HISTORIC AND DESIGN REVIEW COMMISSION May 01, 2019

HDRC CASE NO: 2019-213

ADDRESS: 100 PLAZA DE ARMAS

TYPE OF WORK: Installation of an ADA ramp, site and landscaping modifications

A 102.3

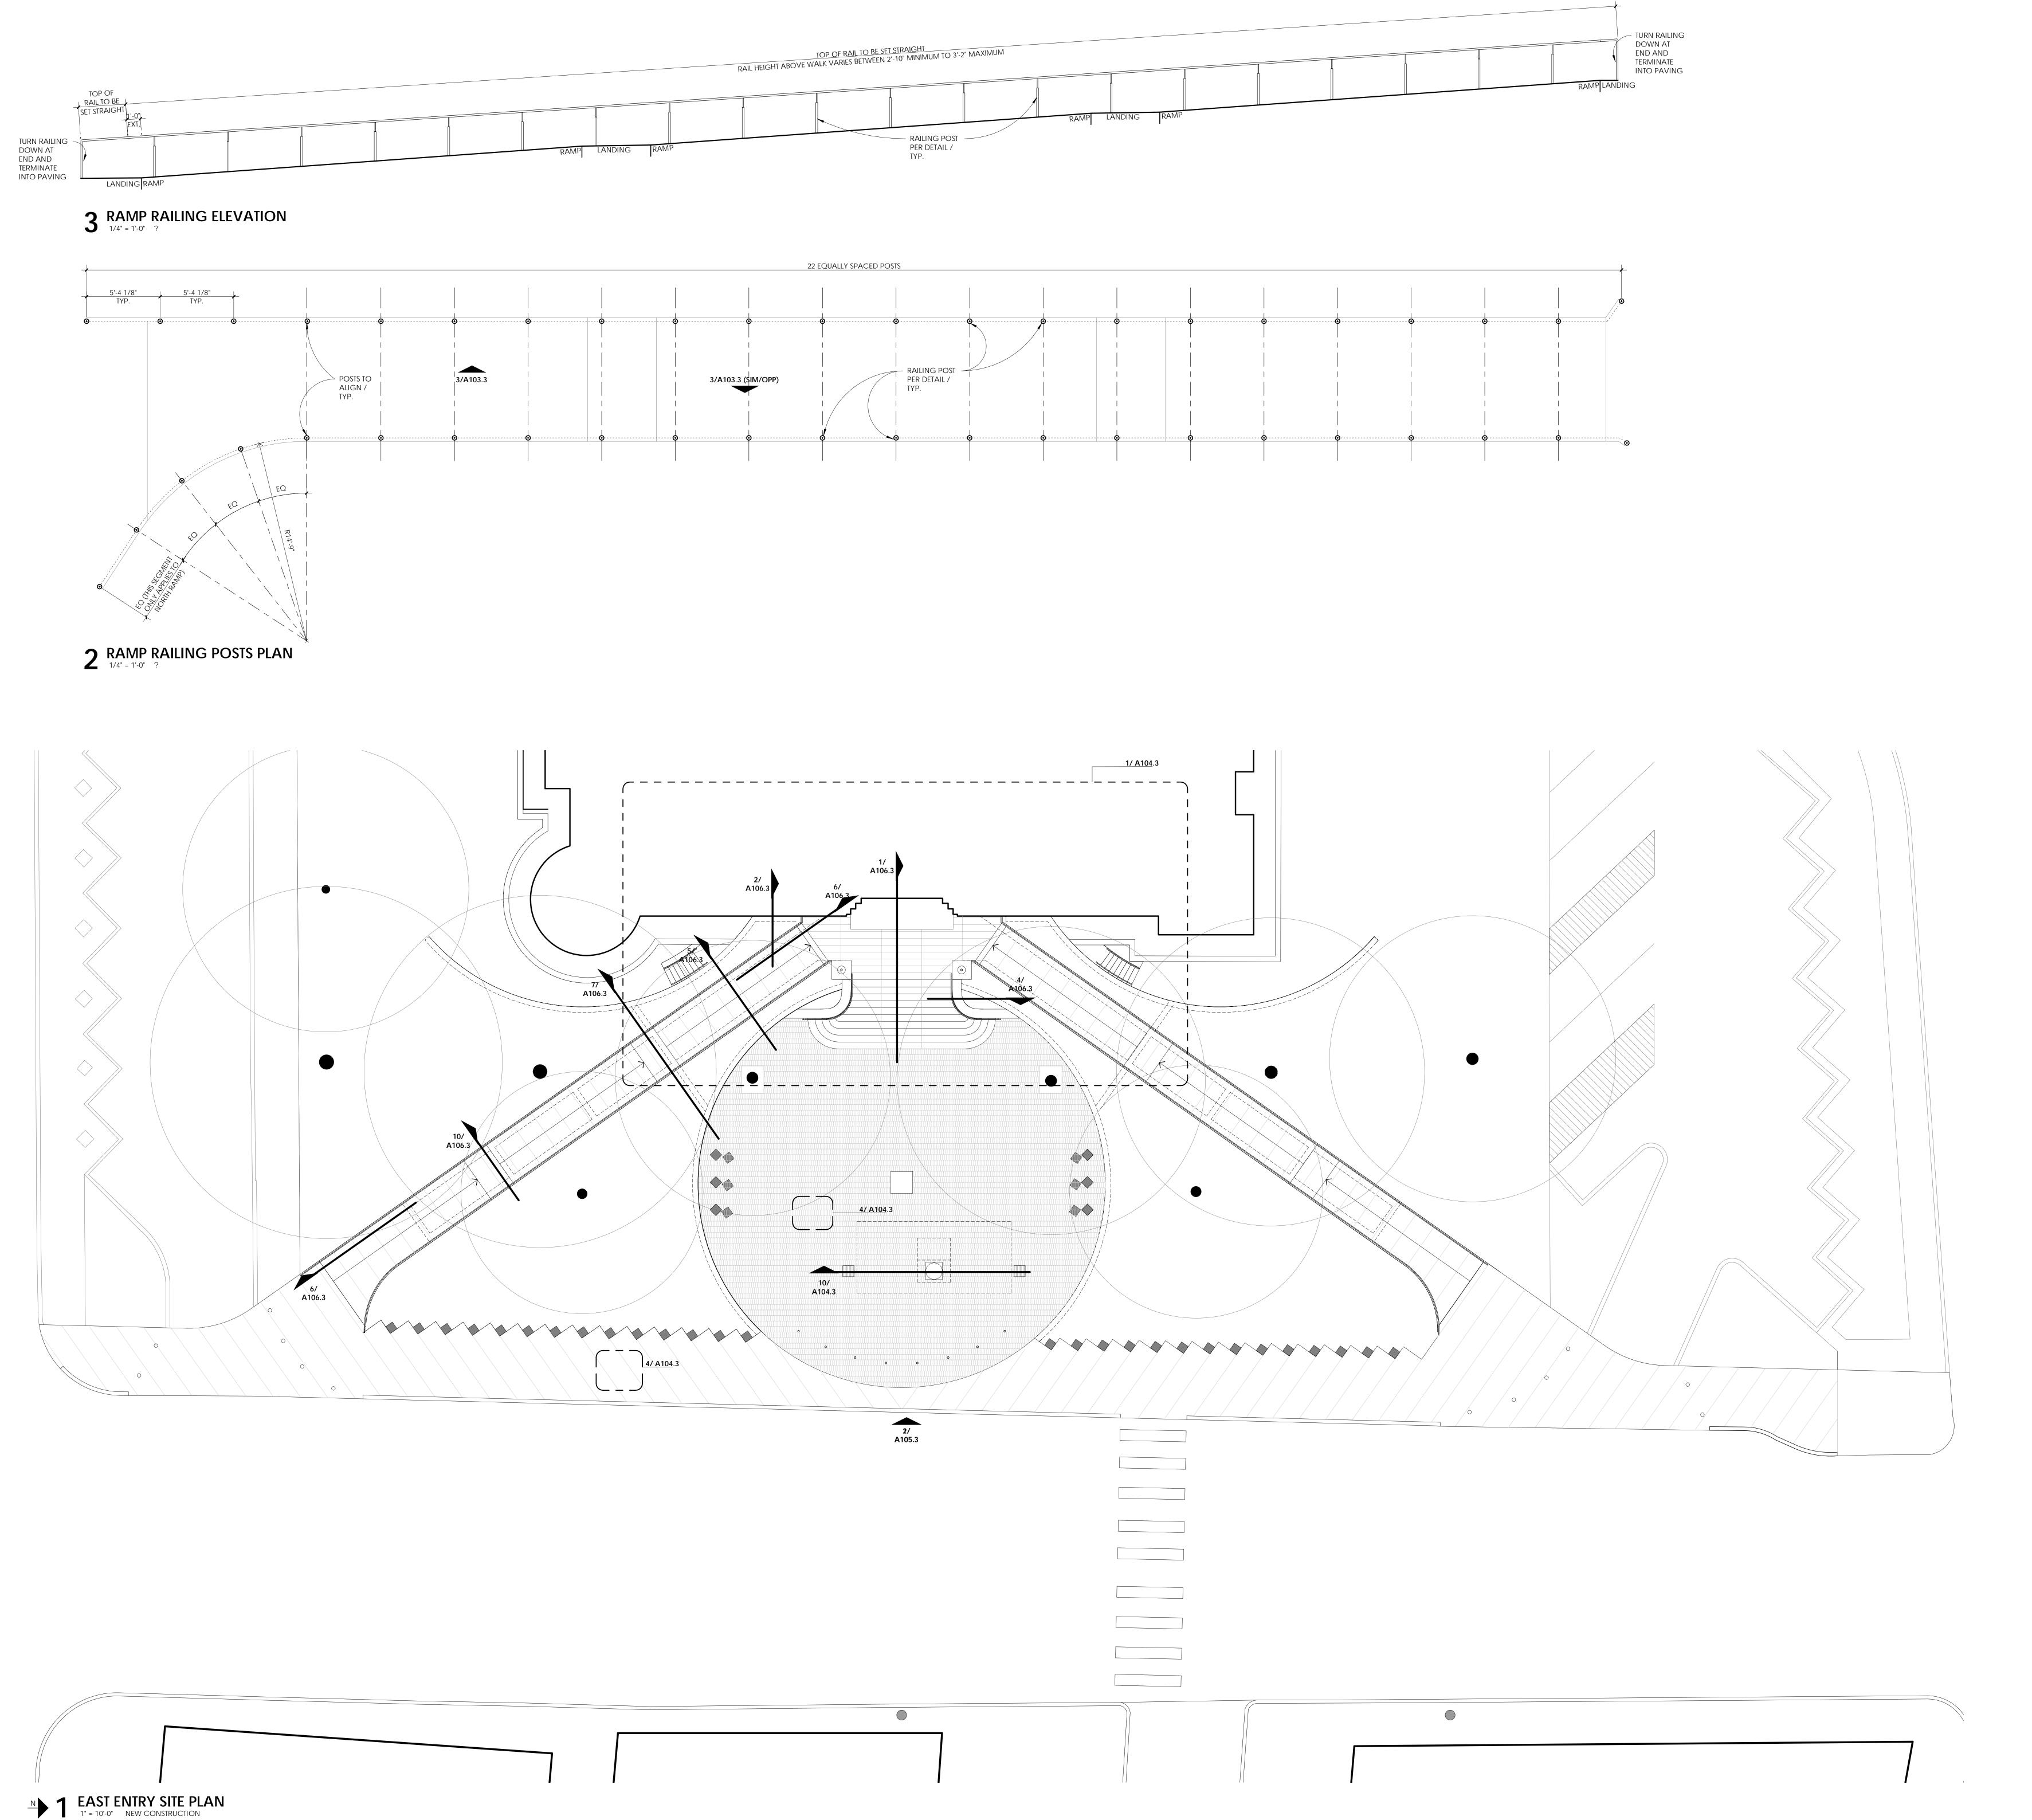
- d. ADA RAMP & NEW STAIR The applicant has proposed to construct an ADA entrance ramp on the east (S Flores) façade of the historic structure. The construction of this ramp will include a new formal entry stair that is to mirror the profile and geometry of the existing stairs, two sets of stairs to lead down to the basement and two broad ramps that will ascend from the northeast and southeast corners of the site that feature flared bases. In addition to the two ramp masses, the applicant has also proposed to shift the east curb forward proportionally to the stair, raise the ground plane to rise with the ramps to eliminate the need for guardrails to present the ramps as a cohesive part of the landscaping and add a circular plaza between both ramps. The applicant has noted that the proposed ramp will feature concrete paving and bronze handrails.

- e. ADA RAMP & NEW STAIR— At the time of conceptual approval, it was stipulated that the proposed new stair be a close match to the original regarding both appearance and materials and that every attempt be made to use carved stone, and that if carved stone was not an option, that cast stone that matches the original in detailing be used. The applicant has elected to use cast stone. Staff finds that the applicant continue to explore the use of cut stone. Staff finds that if cut stone cannot be used, then sufficient information be provided to note why it cannot be used. Staff finds that all new stone should be detailed and installed in a manner that matches the existing as closely as possible. Details of this should be included in documents that are submitted to OHP staff. Additionally, staff finds that the profile of the new steps should appear as closely as possible to the original.

- i. That the applicant continue to explore the use of cut stone, rather than cast stone. If cut stone cannot be used, then then sufficient information should be provided noted why it cannot be used. All new stone should be detailed and installed in a manner that matches the existing as closely as possible. Details of this should be submitted to OHP staff. Additionally, the profile of the new stairs should appear as closely as possible to the original.
- ii. ARCHAEOLOGY Archaeological investigations shall be required. The archaeological scope of work should be submitted to the Office of Historic Preservation archaeologists for review and approval prior to beginning the archaeological investigation. The development project shall comply with all federal, state, and local laws, rules, and regulations regarding archaeology including the Health and Safety Code of Texas.

PLANTING
PLAN

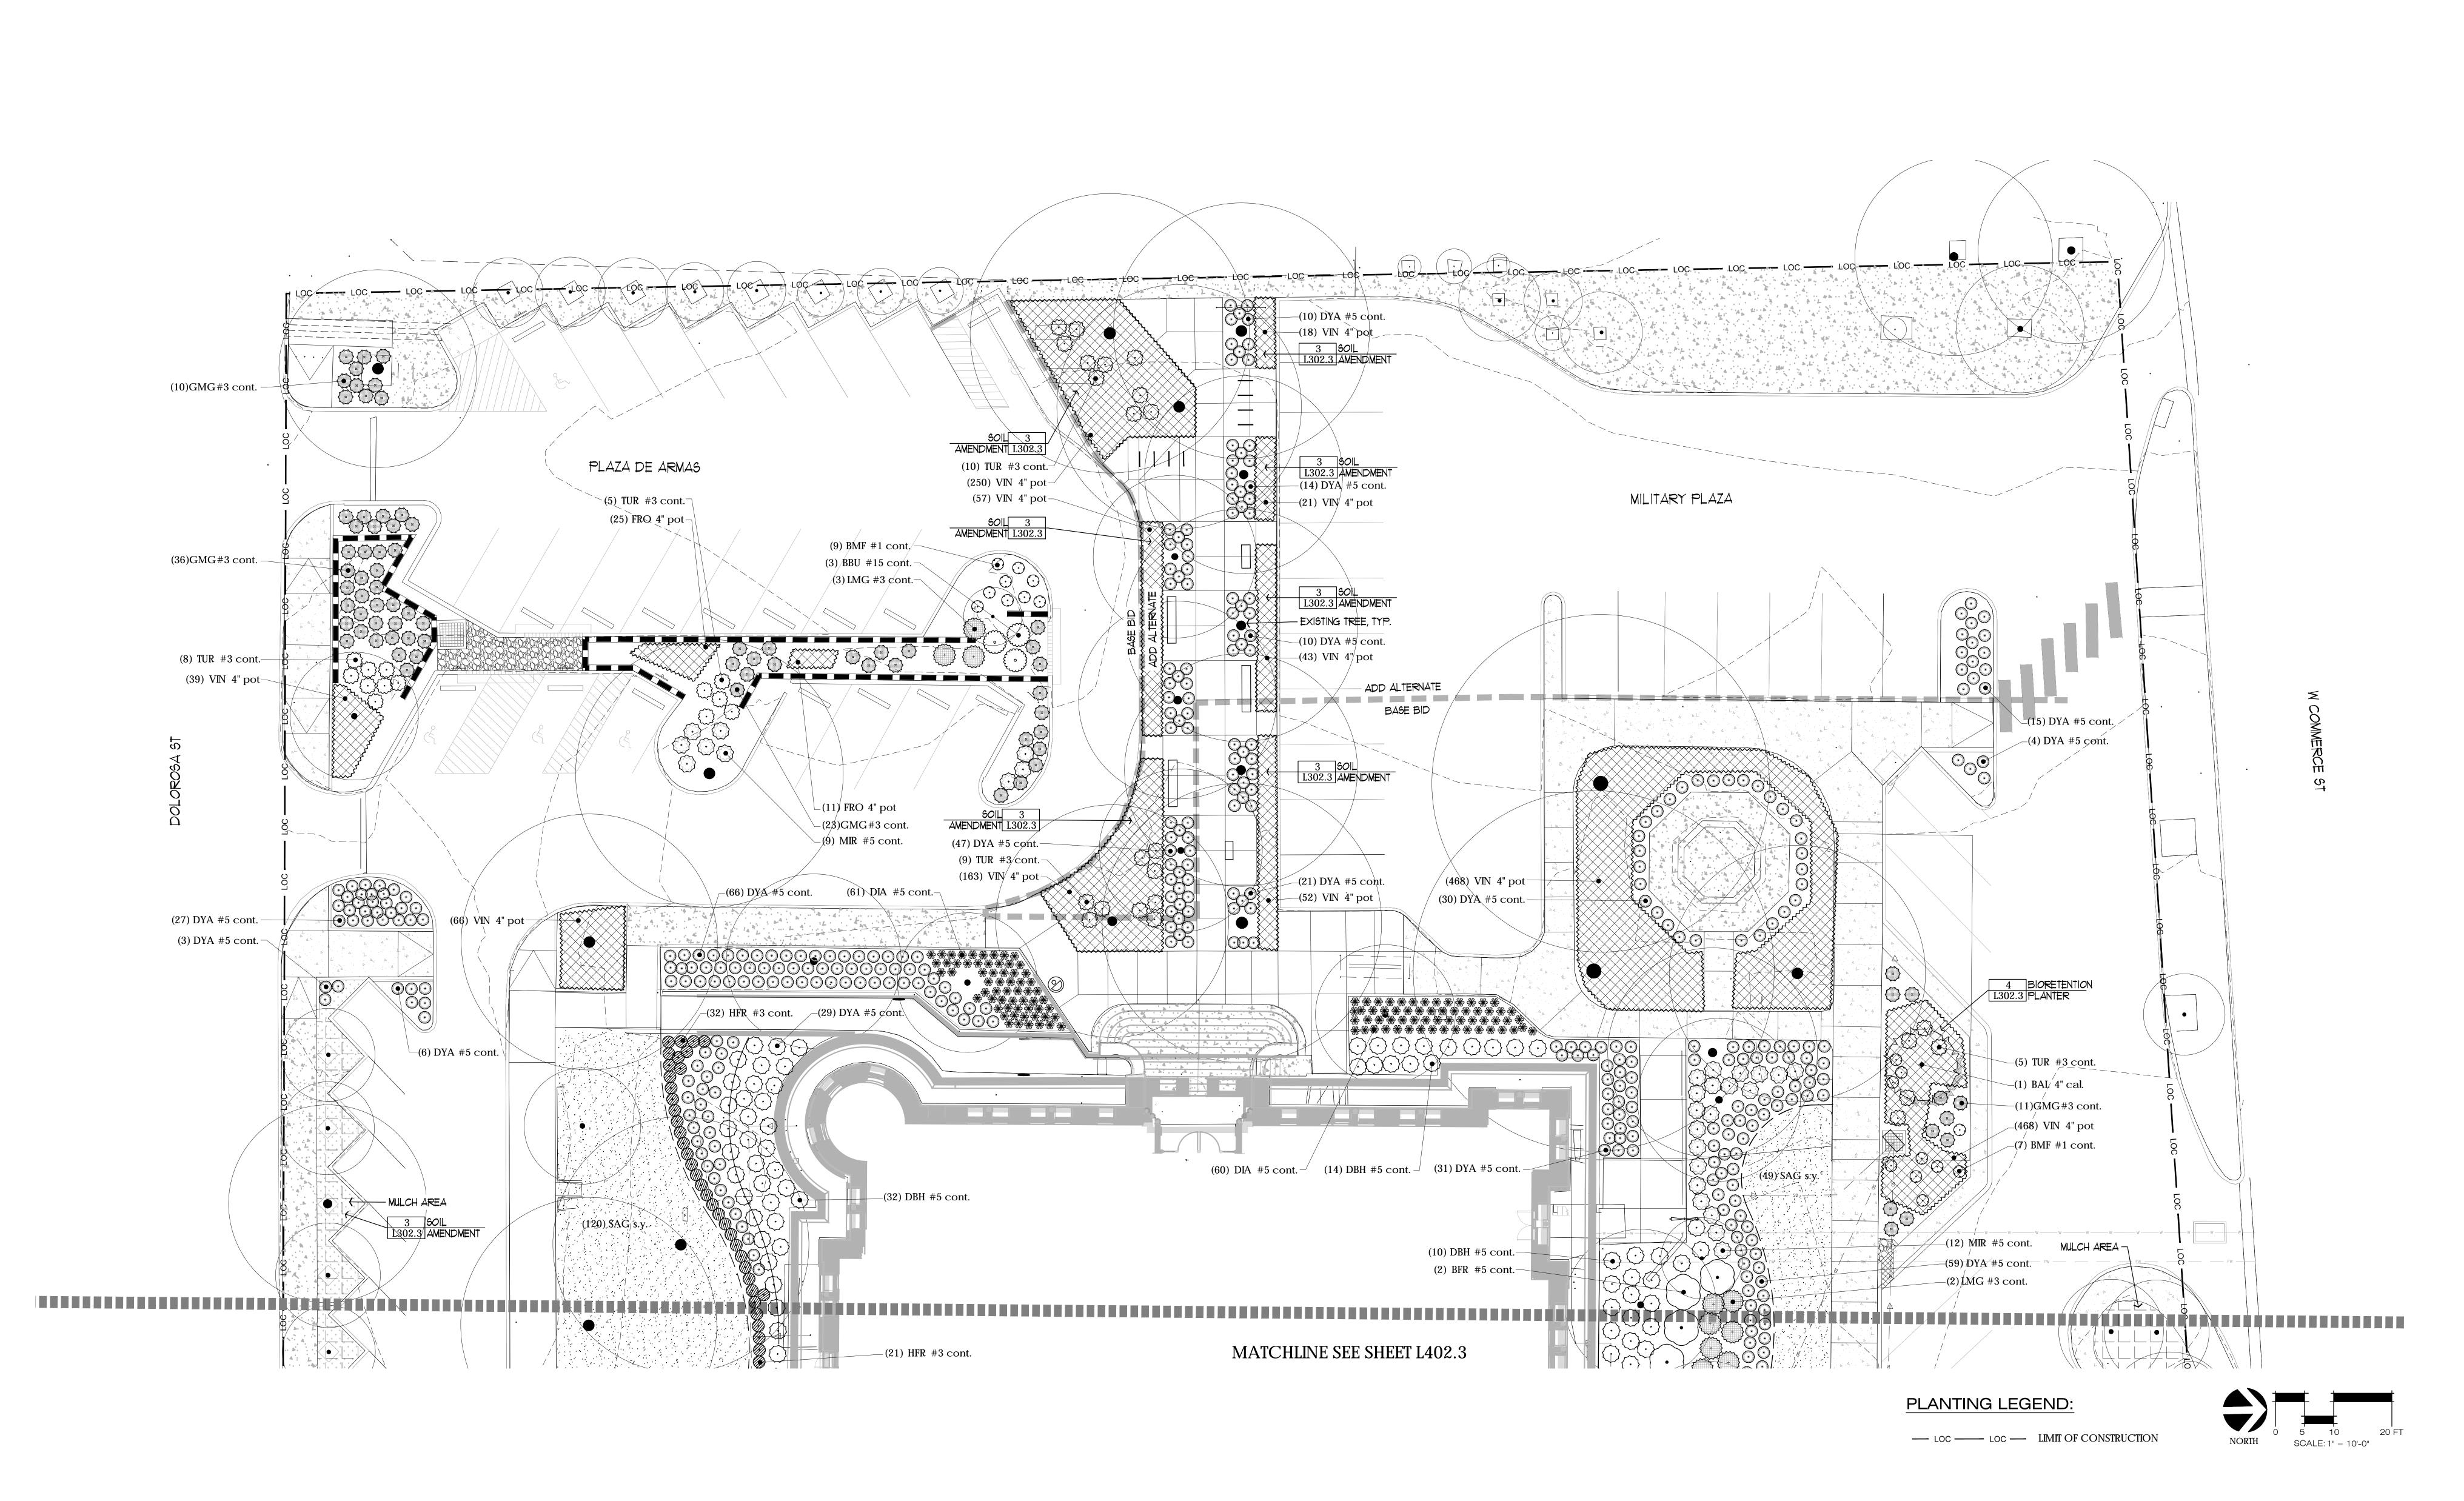
- h. LANDSCAPING The applicant has submitted both a landscaping plan and a list of landscaping materials. Additionally, the applicant has provided information regarding the preservation of existing site trees. Staff finds the proposed landscaping to be appropriate.

ZH: QUESTIONS PEGARNING PLANTING BEAS.
